Subject: MHI's Responses to US-APWR DCD RAI 400-3032 Rev.0, 401-3031 Rev.0,
402-3028 Rev.0 and 403-3027 Rev.0

**Responses to Request for Additional Information No.400-3032
Revision 0**

**US-APWR Design Certification
Mitsubishi Heavy Industries
Docket No. 52-021**

RAI NO.: NO. 400-3032 REVISION 0
SRP SECTION: 11.05 – Process and Effluent Radiological Monitoring
Instrumentation and Sampling Systems
APPLICATION SECTION: 11.5
DATE OF RAI ISSUE: 06/18/2009

Figure 1 Containment Activity

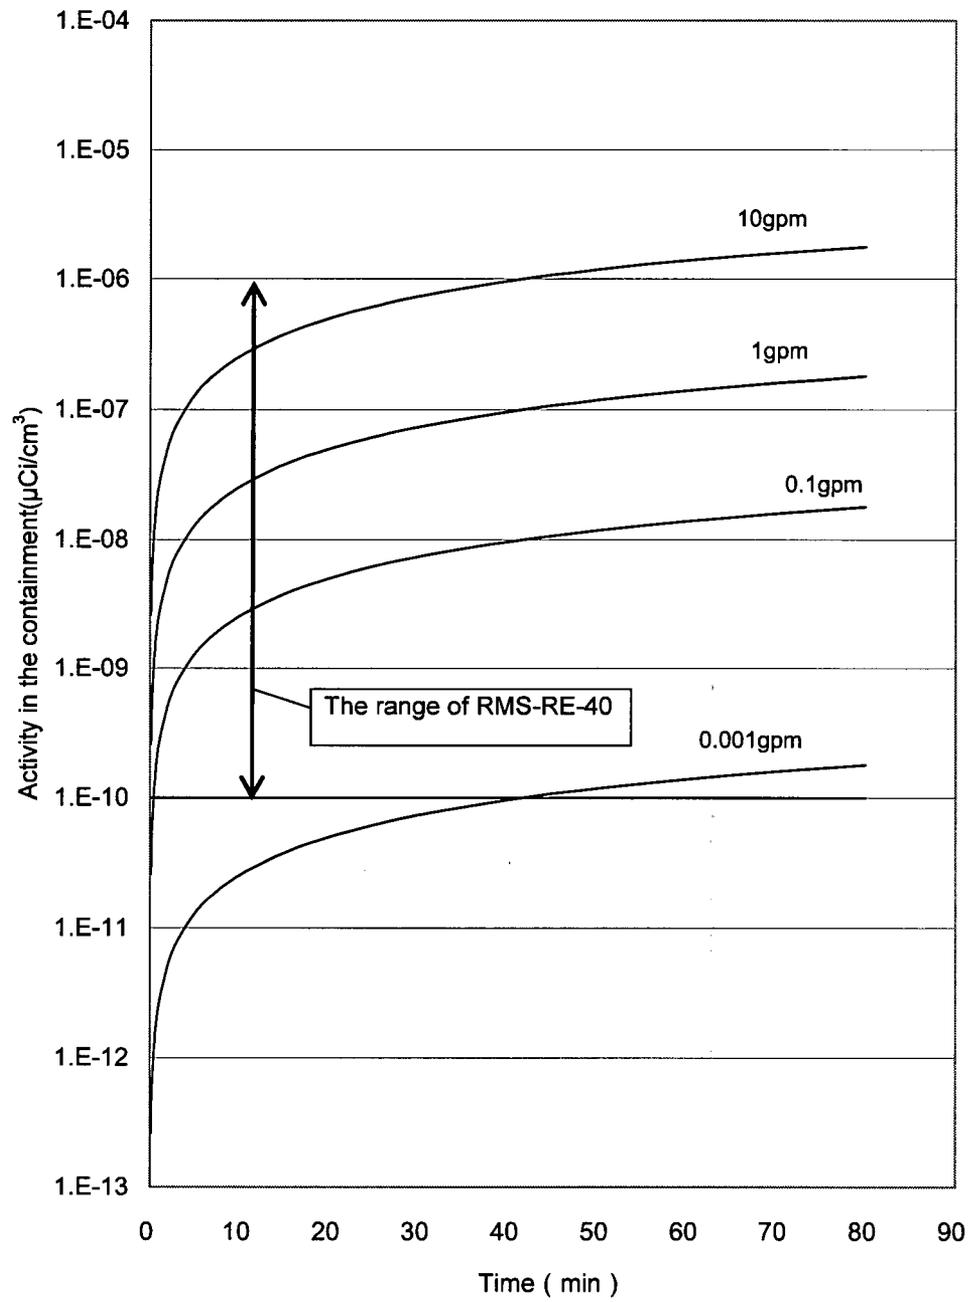
1. Submit a detailed evaluation which demonstrates that the containment particulate radiation monitor range provides the capability to detect leakage of "less than 0.5 gpm within one hour of detector response time" using a realistic radioactive concentration in the RCS, or describe the program and procedure that will be used to satisfy the RCS leakage rate technical basis and RG 1.45 (Rev 1). Revise the DCD to include this information and provide a markup in your response.
2. Update reference of RG 1.45 (Rev 0) to its current revision (Rev 1) in Table 1.9.1- 1 of DCD Section 1.9, and DCD Sections 5.2.5.4.1.2 and 5.2.7, and provide a markup in your response.

1. When reactor coolant leakage into the containment has occurred, the radioactivity concentration inside the containment increases is modeled by the following differential equation (Equation 1), based on an activity balance of the RCS. The integrated form of this equation is presented in Equation 2. The radioactivity inside the containment resulting from varying leakage rates was then calculated as a function of time, based on the parameters listed in Table 1. The results of this calculation are presented in Figure 1. Activity in the containment is detected by the containment radiation particulate monitor (RMS-RE-40) which has a range of 1×10^{-10} to 1×10^{-6} $\mu\text{Ci}/\text{cm}^3$ as listed in DCD Table 11.5-1 and indicated with arrows in Figure 1. This range ensures the capability to detect leakage of less than 0.5 gpm within one hour of detector response time.

Activity in the containment is calculated from the following equations.

"The containment radiation monitor used to detect leakage into the containment from the RCS has a range which is determined to have the capability of detecting less than 0.5 gpd leakage within one hour of response time. This determination is made by applying an activity balance based on the containment radioactivity concentration analysis and showing that this equation, as a function of time, represents an activity leak rate that is within the selected range for the monitor."
